THE HILLHOUSE LITE SUBDIVISION

Engineering Comments: FINAL PLAT COMMENTS (should be addressed prior to submitting the FINAL PLAT for review and/or signature by the City Engineer):

APPLICATION NUMBER 2 DATE December 15, 2022

DETAIL SITE PLAN

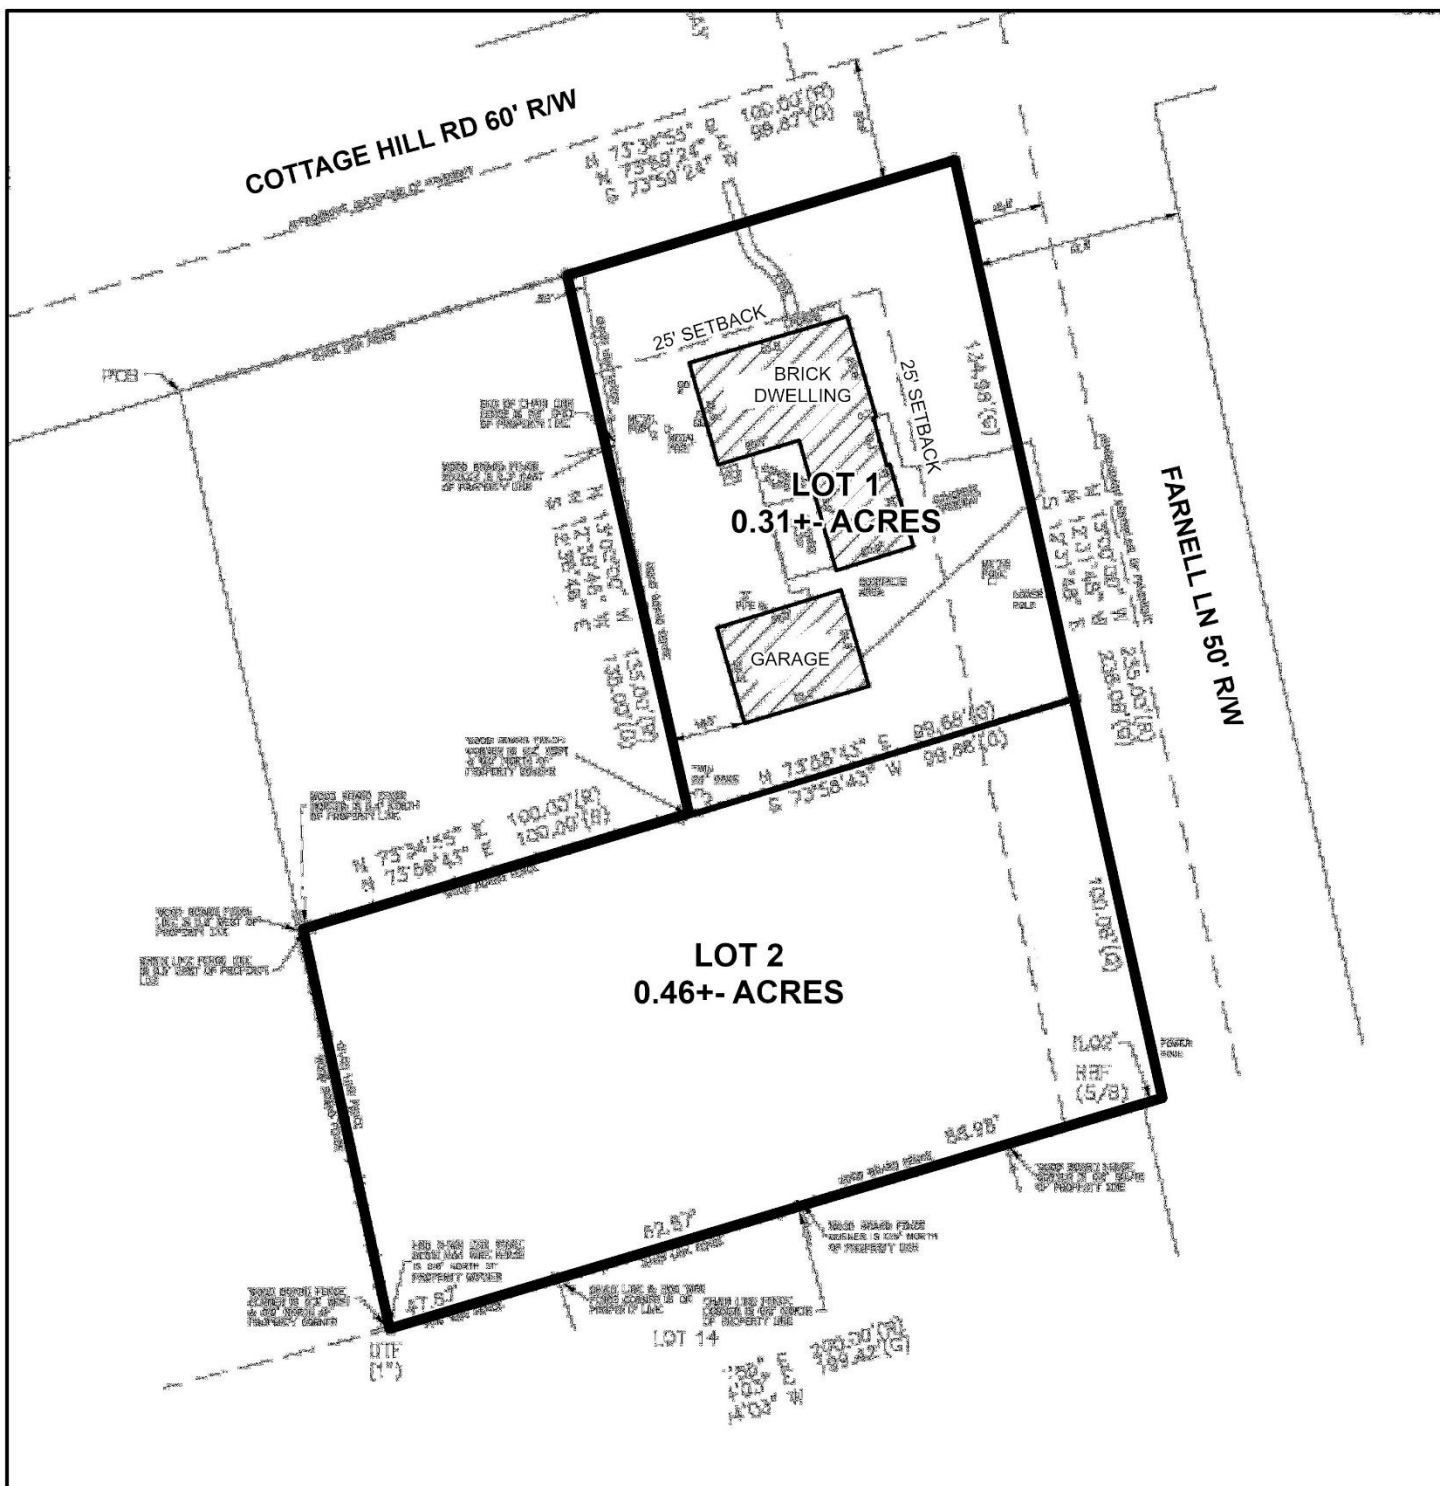
- B. Provide and label the monument set or found at each subdivision corner.
- C. Provide a written legal description and matching bearing and distance labels for the proposed subdivision boundary. It should not include property that is not included in the proposed subdivision.

- D. Provide the bearing and distance for the portion of the subdivision boundary that follows the eastern line of LOT 2.
- E. Provide additional information for the SE corner of LOT 2. What is set or found at the corner?

- F. Label the different lines along the east subdivision boundary line.
- G. Dedicate the corner radius (25' minimum or as approved by the City Engineer and Traffic Engineer) at the northeast corner of LOT 1 to the City of Mobile, and list the amount of dedicated acreage and square feet.

- H. Add a note to the SUBDIVISION PLAT stating that as shown on the 1984 aerial photo (FLIGHT 25 - #76) LOTS 1 and 2 will share the historical credit of existing (1984) impervious area towards stormwater detention requirement per Mobile City Code, Chapter 17, Storm Water Management and Flood Control) as follows: LOT 1 – 2,500 sf and LOT 2 – NONE.

The proposed subdivision has frontage on Cottage Hill Road, a major collector street without curb-and-gutter requiring a 60-foot right-of-way, and Farnell Lane, a minor street with curb-and-gutter requiring a 50-foot right-of-way. The preliminary plat depicts a 60-foot right-of-way along Cottage Hill Road at this location, which is sufficient according to the Major Street Plan. A 50-foot right-of-way is depicted along Farnell Lane and is also sufficient. As such, no additional

The plat should be revised to illustrate dedication of the corner radius at Cottage Hill Road and Farnell Lane, per Section V.D.6 of the Subdivision Regulations.

The preliminary plat submitted illustrates the 25-foot minimum building setback line along both Cottage Hill Road and Farnell Lane, which meets the minimum requirements of Section V.D.9 of the Subdivision Regulations. If approved, this information should be retained on the Final Plat.

Both lots exceed the minimum size requirements of the Subdivision Regulations, and the lot sizes are provided in square feet and acres on the Preliminary Plat. This information should be retained on the Final Plat, if approved.

- 1) Retention of the right-of-way widths of Cottage Hill Road and Farnell Lane on the Final Plat;
- 2) Dedication of the corner radius at the intersection of Cottage Hill Road and Farnell Lane, per Section V.D.6.;

- 3) Retention of the 25-foot minimum building setback line along Cottage Hill Road and Farnell Lane, per Section V.D.9.;
- 4) Retention of the lot sizes in square feet and acres on the Final Plat;
